ENVIRONMENTAL PROTECTION AGENCY

Re: 1110905002 -- McHenry County  
Aubrey Manufacturing Company  
ILD005238159  
Log No. C-686-M-2  
Received: June 10, 1993  
RCRA - Closure

This letter is in response to a document titled "Background Soil Sampling Report", dated June 9, 1993 and received by the Agency on June 10, 1993. This document was prepared by ERM Enviroclean - North Central, Inc. on behalf of Aubrey Manufacturing Company and contained the results of the background soil sampling conducted on April 27, 1993 in the vicinity of the hazardous waste surface impoundment undergoing RCRA closure at the above referenced facility. This submittal is hereby approved subject to the following conditions and modifications:

**DATE:** July 30, 1993  
**TO:** CORE  
**FROM:** Michael A. Heaton, CAU, PS, BOL  
**SUBJECT:** 1110905002 -- McHenry County (Union, IL)  
Aubrey Manufacturing Company (ILD995238159)

FIGURE 3

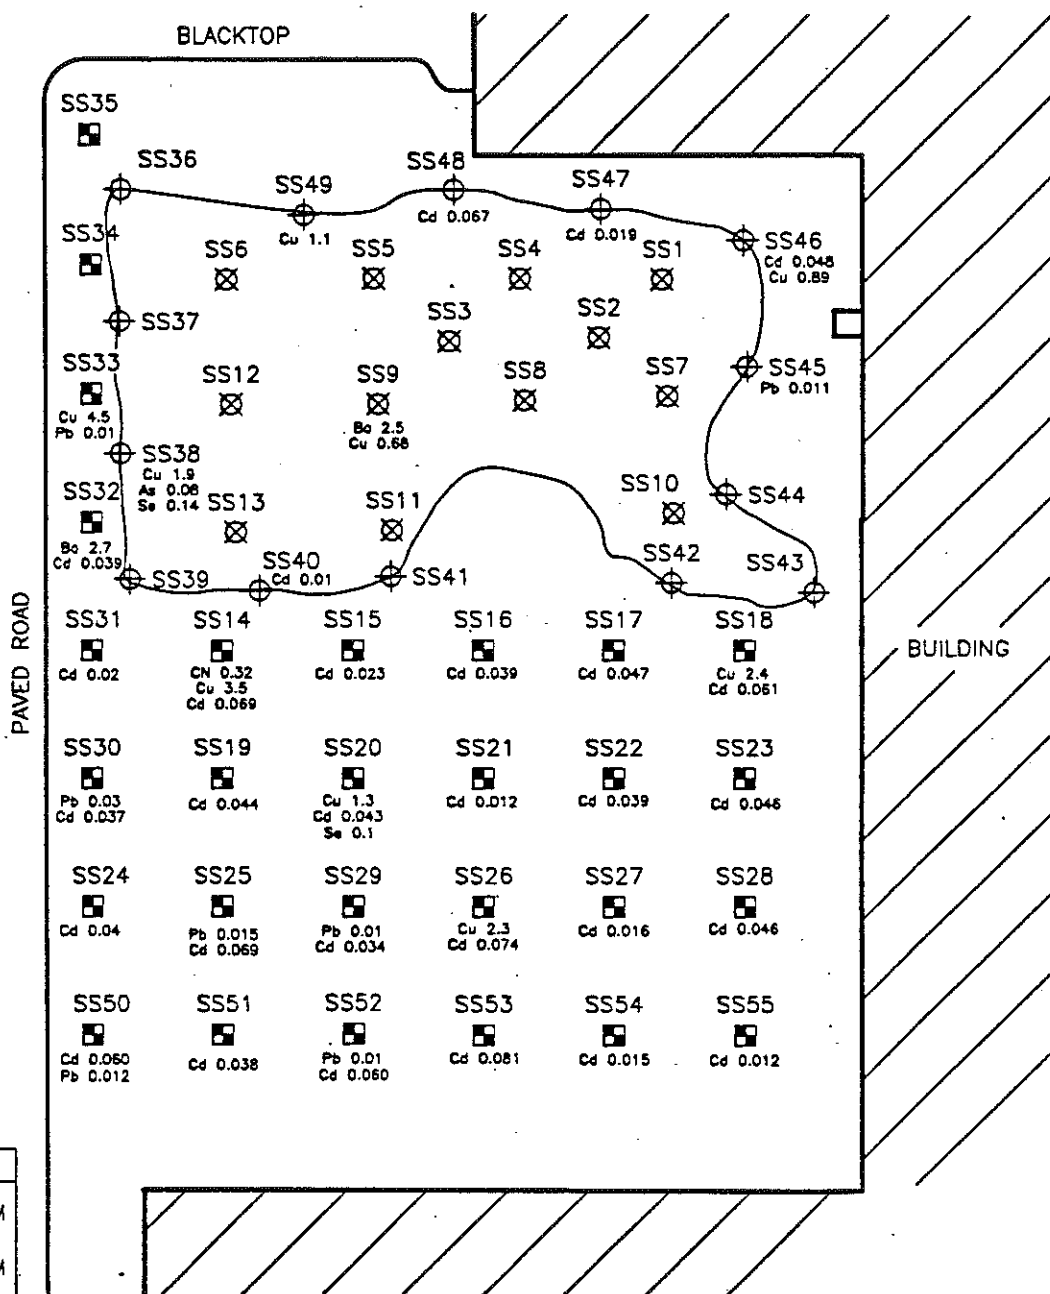
Figure 4 shows the hits at this facility above C40s and background. This table should include a few hits of copper since the Agency rejected the original background concentration for copper. In any event, though, this table does demonstrate that the hits were all "minor" and not laterally consistent. Thus the volume of impacted soil is minor.

Attachment 4 shows the locations and actual concentrations of exceedances of the Agency established CUOs (based upon the protection of Class I groundwater. It should be noted that the facility was required to collect surface soil samples from the areas south and west of the impoundment to determine if these areas had received surface run-off from overflows, etc. of the impoundment and to determine if the machinery used in the excavation of the impoundment had detrimentally affected this area

Attachment 7  
Page 2/2

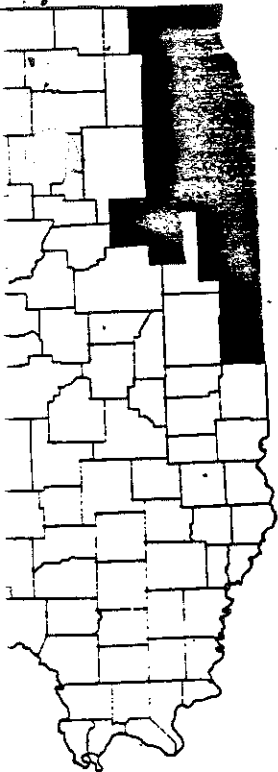
Attachment 7 locates the facility on the map entitled "Potential for Contamination of Shallow Aquifer from Land Burial of Municipal Waste" (ISGS, 1984). Note that on this map the facility is located in Section A2 which is described in Attachment 7, page 2/2 as being "Thick, permeable sand and gravel within 20 ft. of land surface". However, due to the low concentrations and volumes involved and the fill material present at the unit, the CAU does not feel that any contamination would detrimentally affect the groundwater at this facility.
